**SIB 46 03 07****SERVICE ACTION: Replacement Brackets for Fairing Side Panels - 46 003 07 (011)**

Subject: Replacement brackets for fairing side panels

Model: K 1200 R Sport (K43HV)

New version, plastic bracket

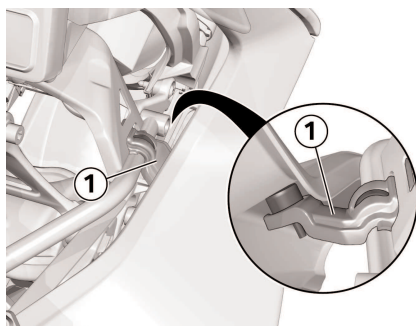
Details: The fairing brackets installed on the early K 1200 R Sport (K43HV) motorcycles were not sufficiently resistant to corrosion. These steel brackets are secured by screws and have to be replaced by the latest version (plastic brackets).

Before customers take delivery or as part of the Pre-Delivery Inspection, remove the screw-secured steel brackets from the motorcycles in question and install the plastic brackets instead. You are also requested to make this change to your demonstrators and showroom-stock motorcycles without delay.

- * Remove both side panels.
- * Remove the screw securing the steel bracket on each side, remove the two steel brackets and scrap them.
- * If necessary, use black paint to touch up minor damage to the paintwork of the instrument carrier.
- * Install the rubber buffers in the plastic brackets (1).
- * Install the plastic brackets (1) on left and right and secure them to the instrument carrier with cable ties.
- * Install both side panels, paying particular attention to their alignment.
